E	12/03/12	Section 75W Submission	PL	MD
D	04/11/11	Revised Design following SOPA comments	JC	MD
B	09/09/11	Revised Design following SOPA comments	MD	MD
A	06/04/11	DA Submission	JL	MD
Revision	Date	Description	Initial	Checked

Site 3
Sydney Olympic Park
Plan
Basement 001

Site 3
Sydney Olympic Park
Plan
Level 19-21

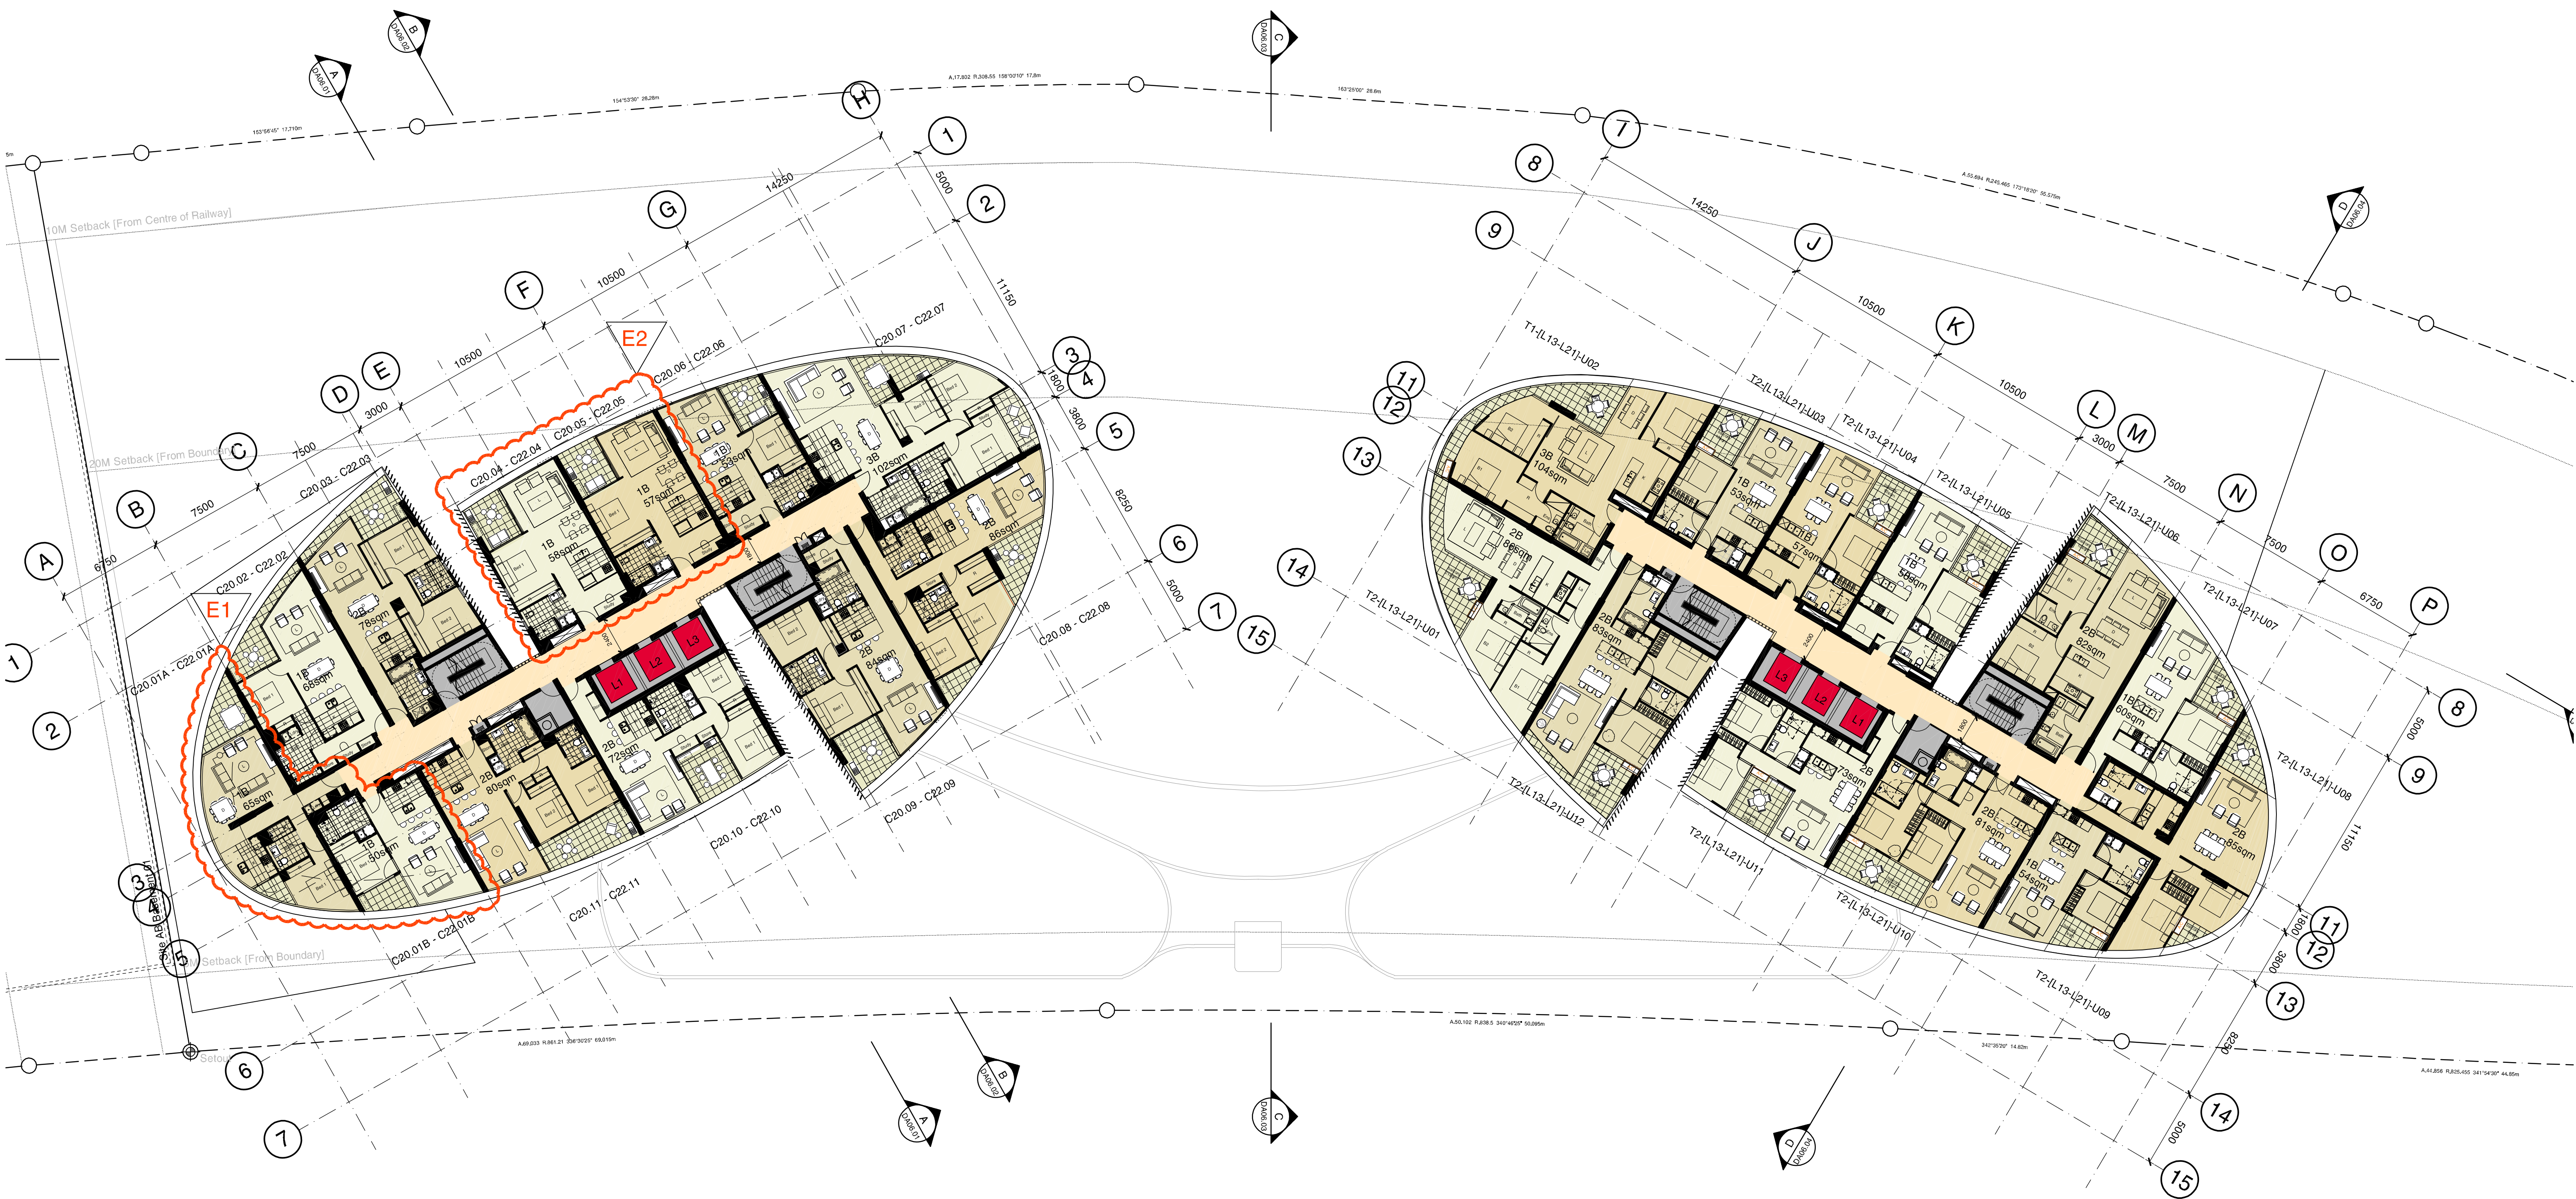
1. Change of apartment mix from one 3-Bed (C14.01-C22.01) to two 1-Bed (C14.01A-C22.01A & C14.01B-C22.01B).

2. Apartments C14.04-C22.04 & C14.05-C22.05 have been allocated as adaptable units.

Site 3
Sydney Olympic Park
Plan
Level 22

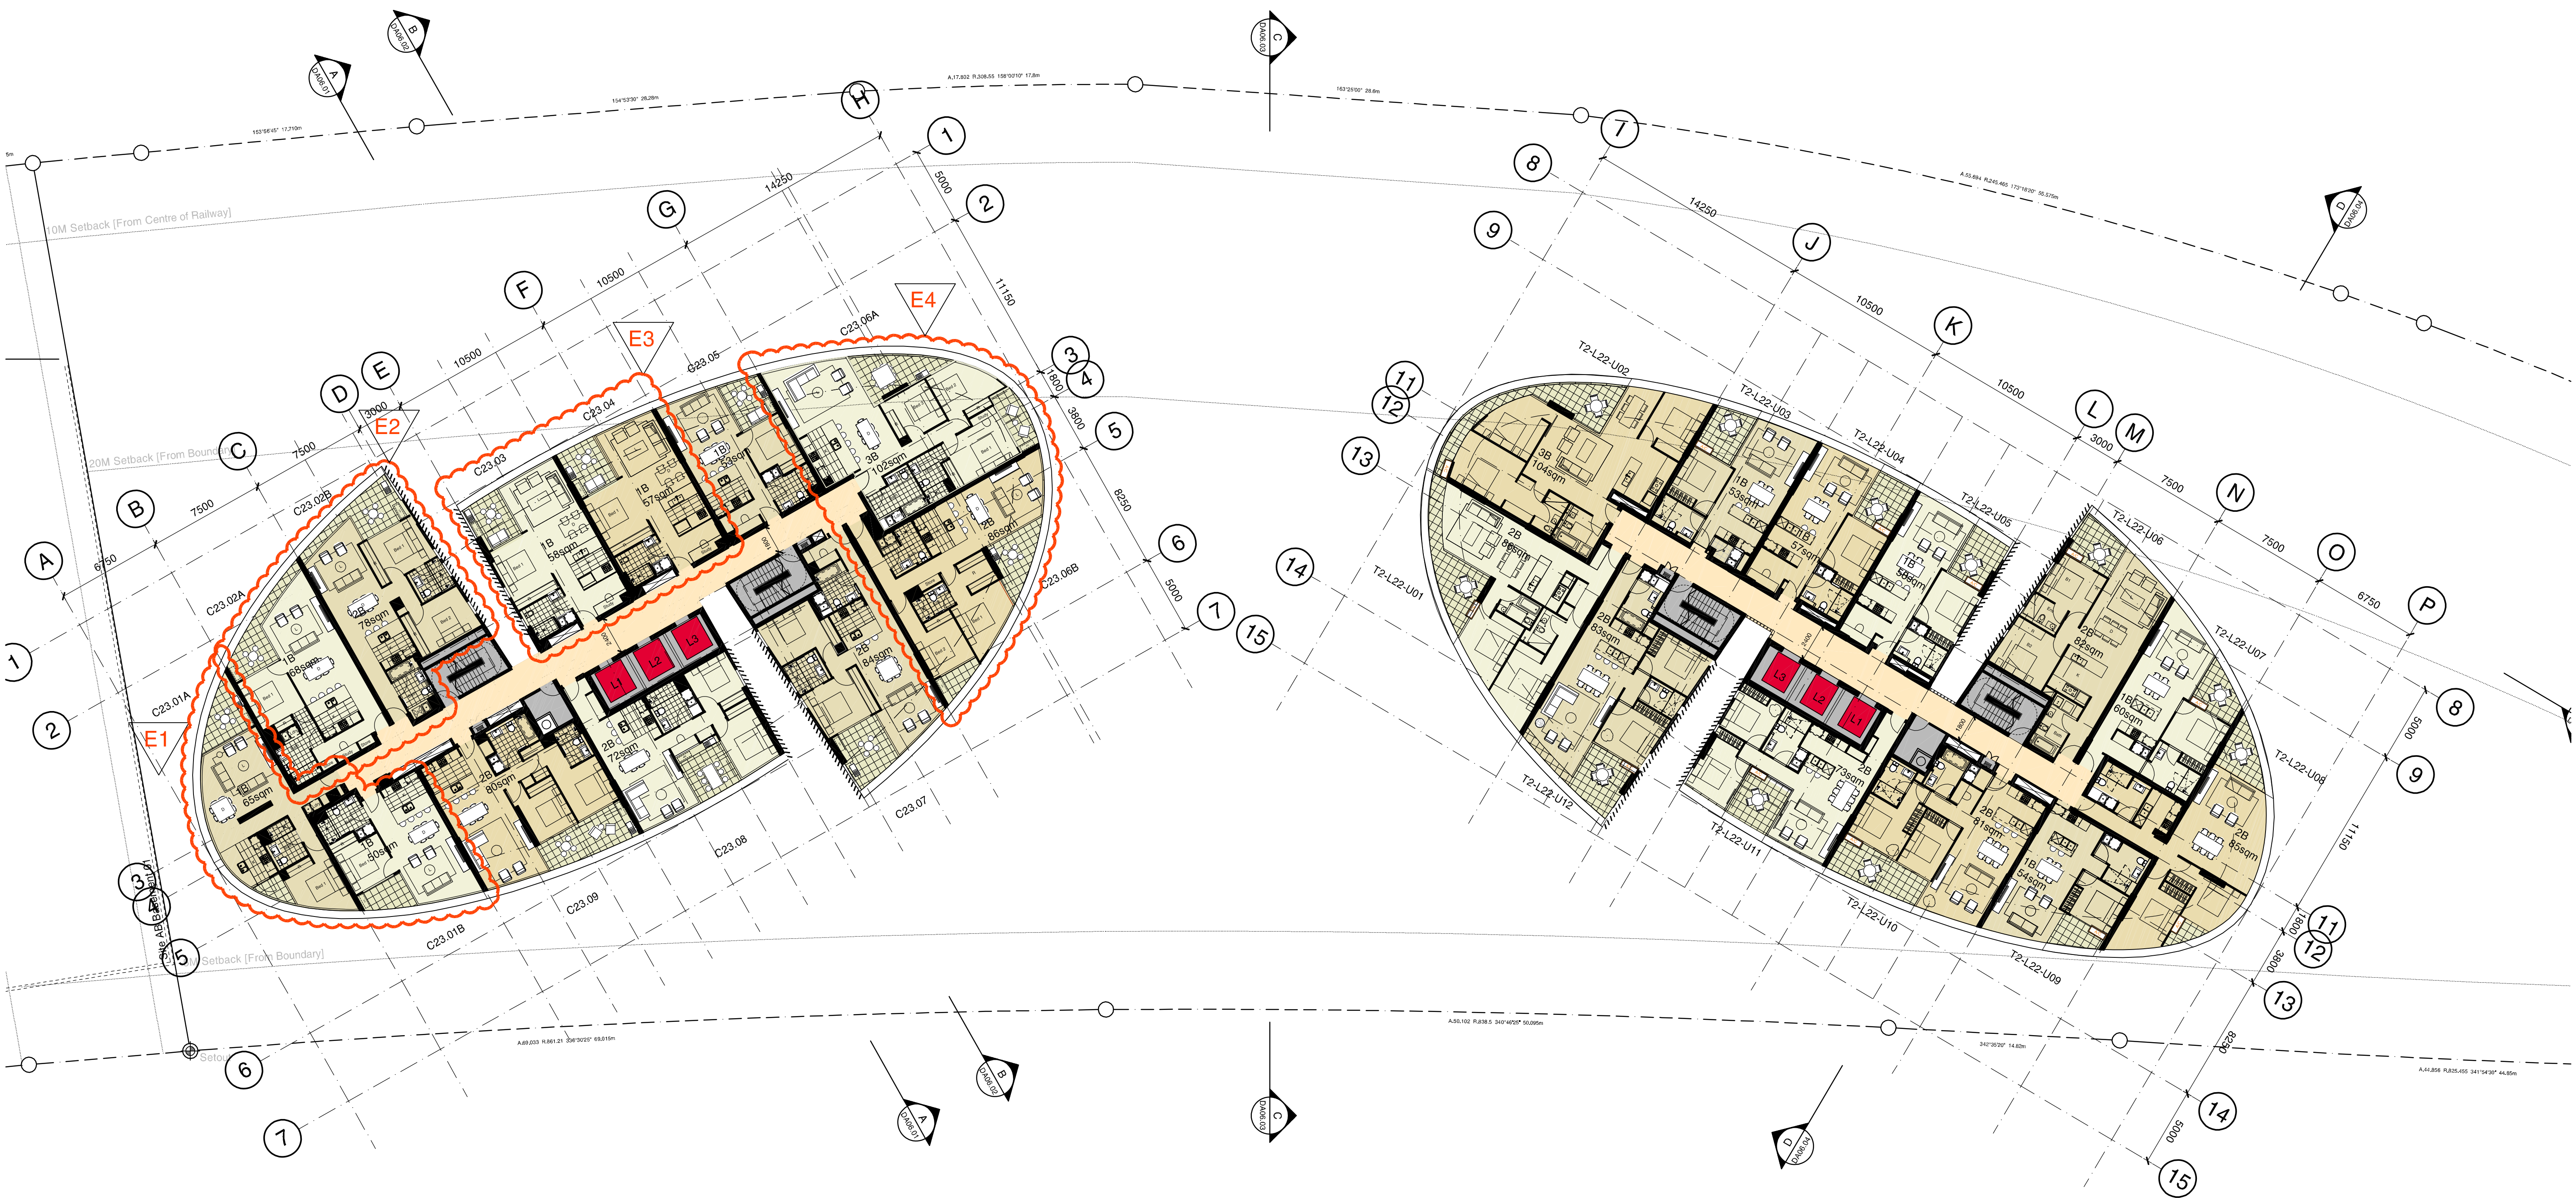
1. Change of apartment mix from one 3-Bed (C23.01) to two 1-Bed (C23.01A & C23.01B).
2. Change of apartment mix from one 3-Bed (C23.02) to one 1-Bed (C23.02A) and one 2-Bed (C23.02B).
3. Apartments C23.04 & C23.05 have been allocated as adaptable units.
4. Change of apartment mix from one 4-Bed (C23.06) to one 2-Bed (C23.06B) and one 3-Bed (C23.06A).

Site 3
Sydney Olympic Park
Plan
Level 23

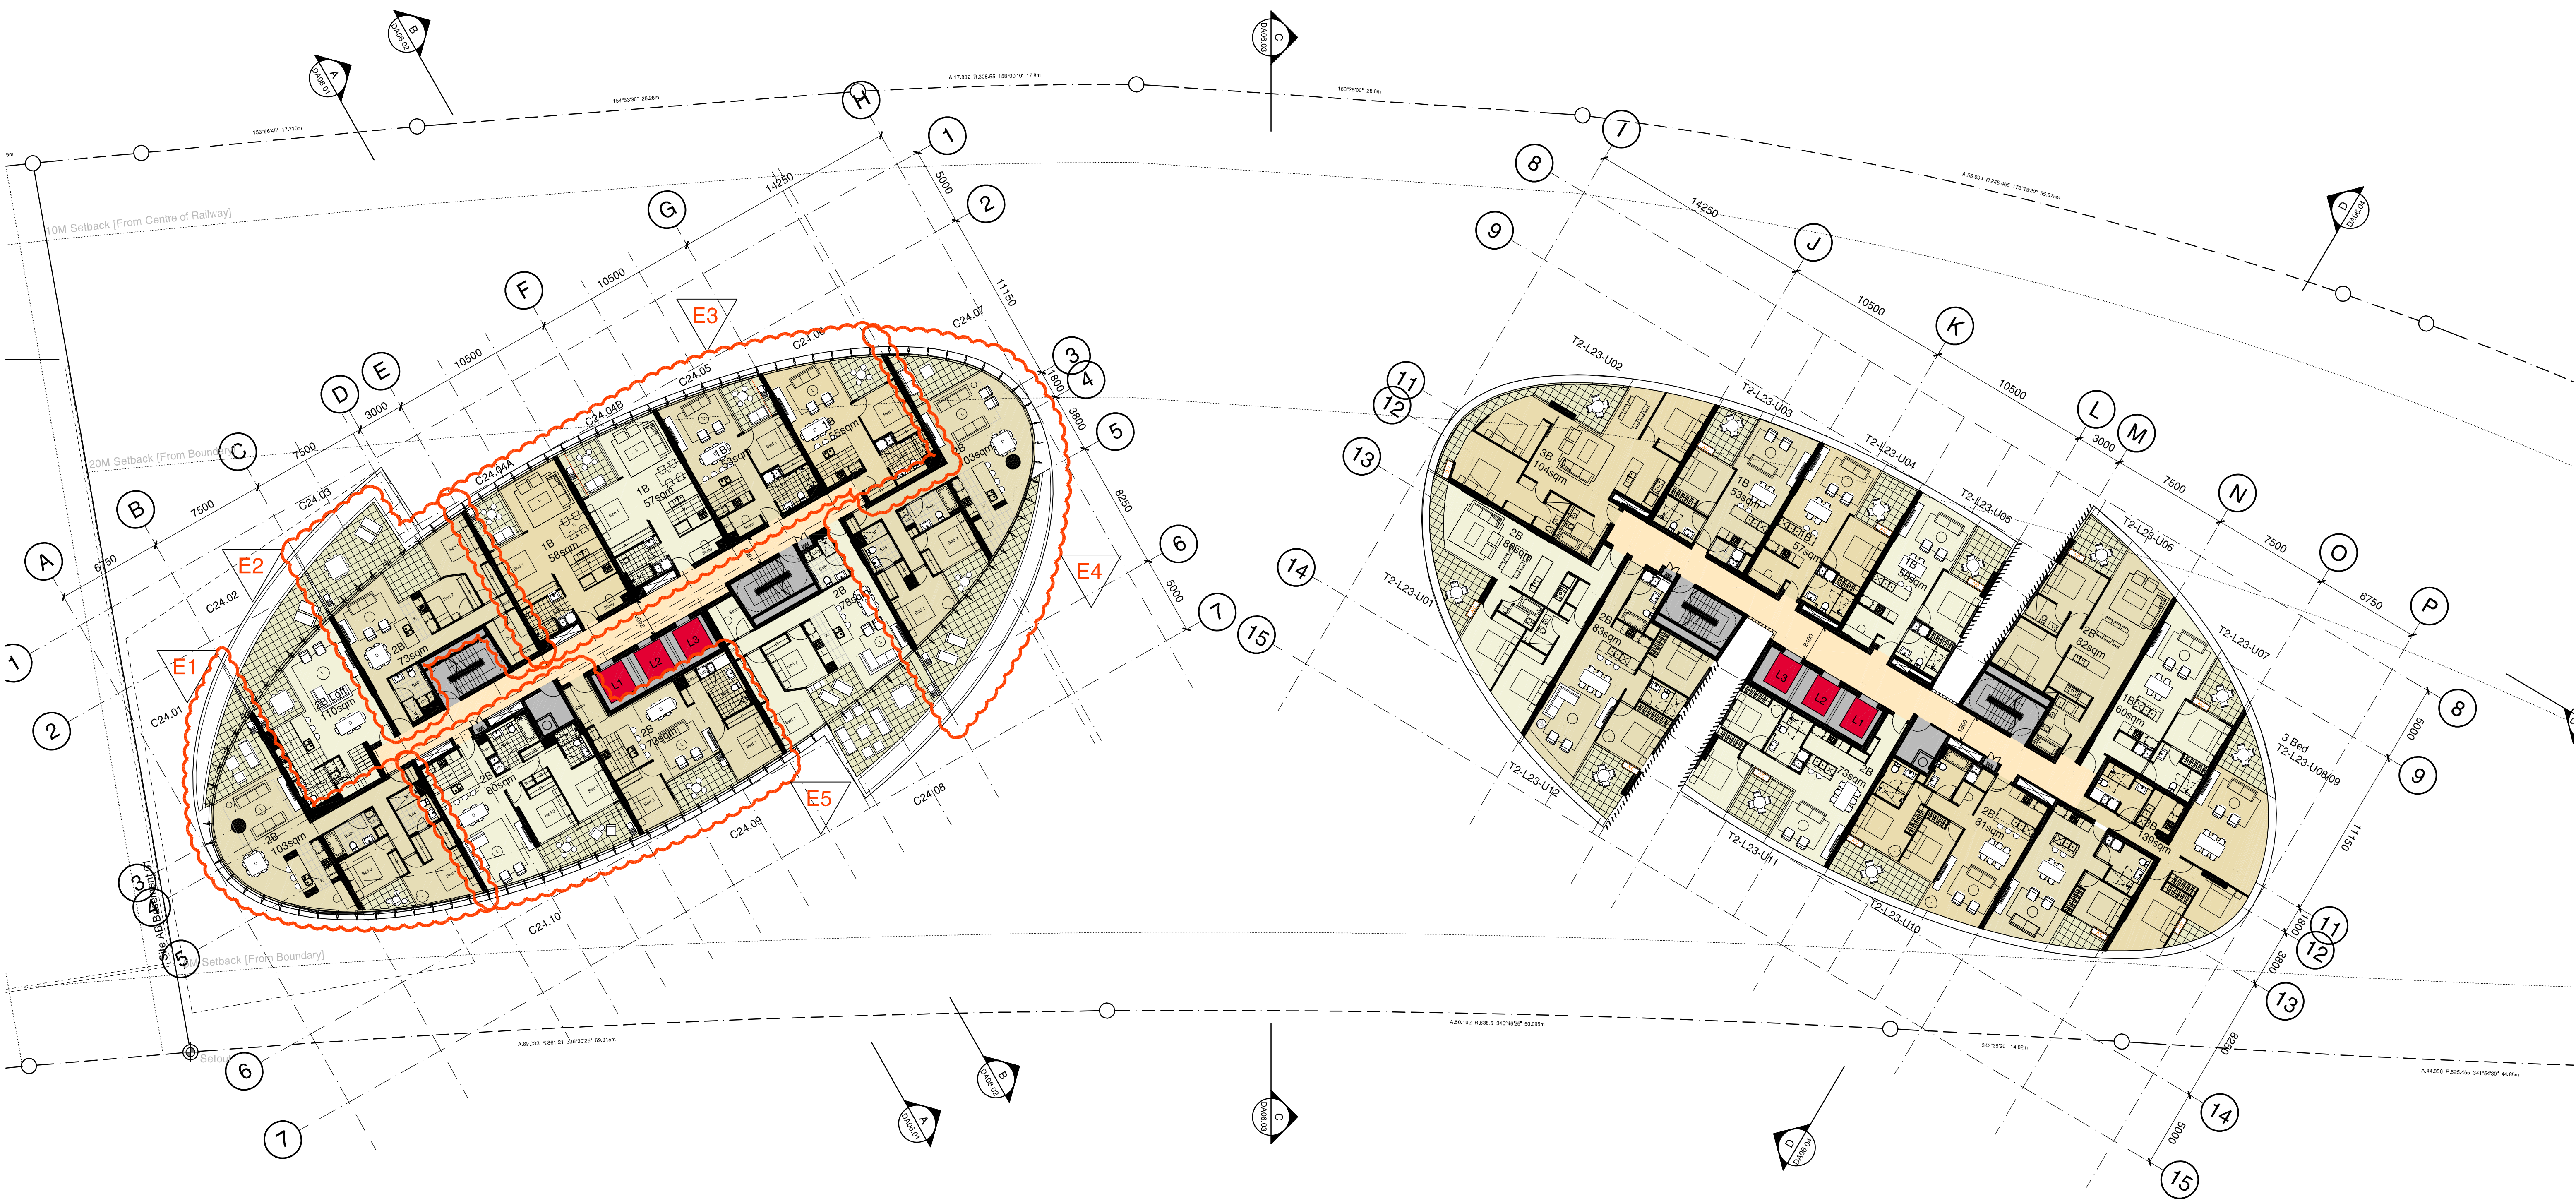
- Revision E - Section 75W Amendments.
- One 3-Bed Loft (C25.01) has been modified to one 2-Bed single storey apartment (C24.01).
 - One 3-Bed Loft (C25.03) has been modified to one 2-Bed single storey apartment (C24.03).
 - One 2-Bed Loft and two 4-Bed Lofts (C25.04, C25.05 & C25.06) have been modified to four 1-Bed single storey apartments (C24.04A, C24.04B, C24.05 & C24.06), including two units allocated as adaptable units.
 - One 3-Bed Loft (C25.07) has been modified to one 2-Bed single storey apartment (C24.07).
 - Change of apartment mix from one 1-Bed and one 3-Bed (C25.09 & C25.10) to two 2-Bed (C24.09 & C24.10).
